Subject: Addendum to Geotechnical Study - 2018 Seismic Update  
Proposed Challenger Pallets Building  
About 1250 West 2150 North  
Farr West, Utah  
CMT Project Number: 12606

As requested, this letter provides the 2018 International Building Code (IBC) update related to seismic parameters previously prepared for this project. The original geotechnical report was completed in April 2019<sup>1</sup> prior to the adoption of the 2018 IBC by the state of Utah. The following paragraphs and tables update Section **4.3 Seismicity** of the project geotechnical report.

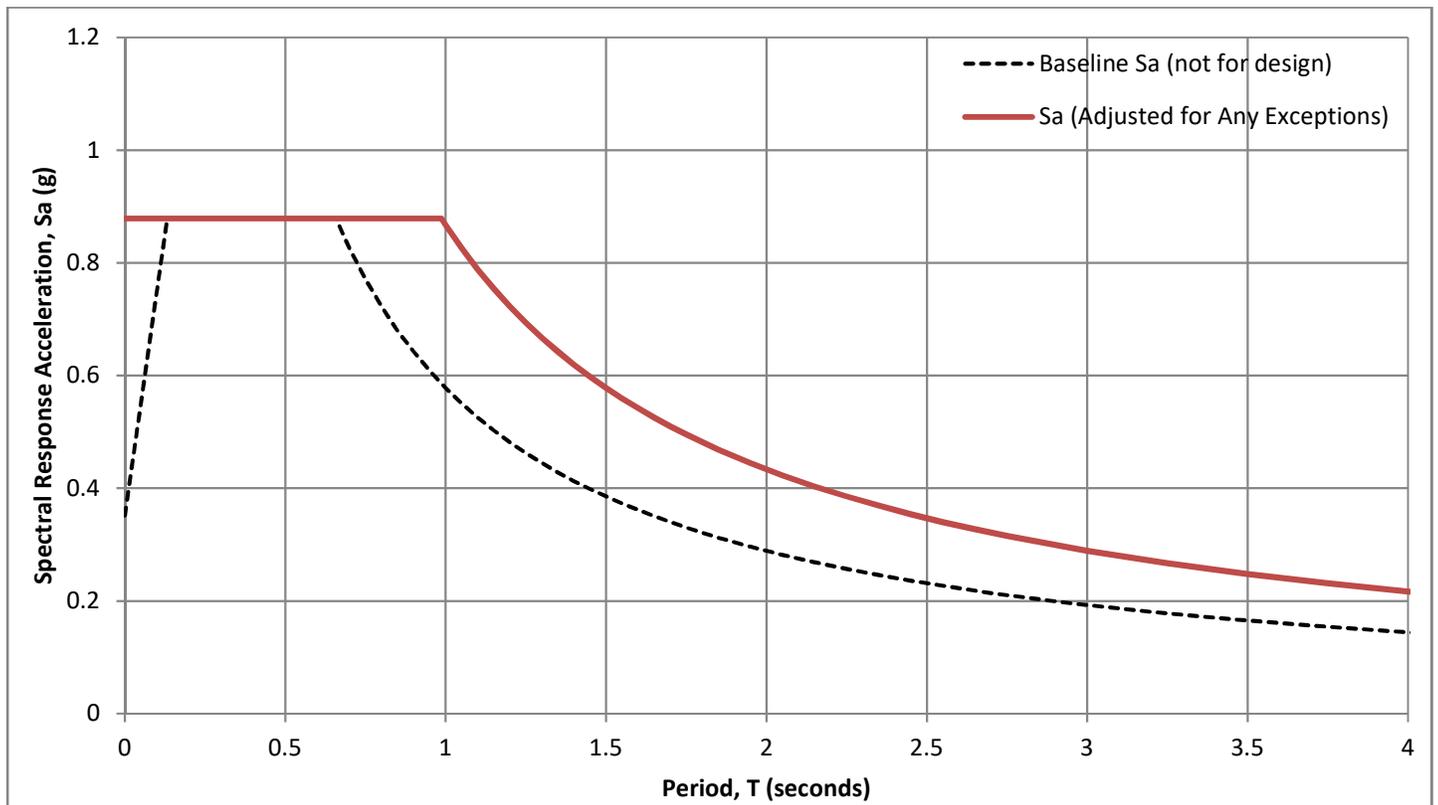
The 2014 USGS mapping utilized by the IBC provides values of peak ground, short period and long period accelerations for the Site Class B/C boundary and the Maximum Considered Earthquake (MCE). This Site Class B/C boundary represents average bedrock values for the Western United States and must be corrected for local soil conditions. The following table summarizes the peak ground, short period and long period accelerations for the MCE event, and incorporates appropriate soil correction factors and any possible exceptions for a Site Class D soil profile at site grid coordinates of 41.29775 degrees north latitude and 112.00901 degrees west longitude (also see response spectrum below):

| SPECTRAL ACCELERATION VALUE, T         | SITE CLASS B/C BOUNDARY [mapped values] (g) | SITE COEFFICIENT  | SITE CLASS D* [adjusted for site class effects] (g) | MULTI-PLIER | DESIGN VALUES (g)  |
| Peak Ground Acceleration               | PGA = <b>0.670</b>                          | $F_{pga} = 1.100$ | $PGA_M = 0.737$                                     | 1.000       | $PGA_M = 0.737$    |
| 0.2 Seconds (Long Period Acceleration) | $S_s = 1.485$                               | $F_a = 1.000$     | $S_{MS} = 1.485$                                    | 0.667       | $S_{DS} = 0.990$   |
|  | (exceptions, if any)                        | $F_a = (N/A)$     | $S_{MS} = (N/A)$                                    | 0.667       | $S_{DS} = (N/A)$   |
| 1.0 Second (Long Period Acceleration)  | $S_1 = 0.538$                               | $F_v = N/A$       | $S_{M1} = N/A$                                      | 0.667       | $S_{D1} = N/A$     |
|  | (exceptions, if any)                        | $F_v = (1.762)$   | $S_{M1} = (0.948)$                                  | 0.667       | $S_{D1} = (0.632)$ |

4. ASCE 7-16 requires Site Specific Ground Motion Hazard Analysis ( $S_1 \geq 0.2$ ), OR Can Use Exception 2
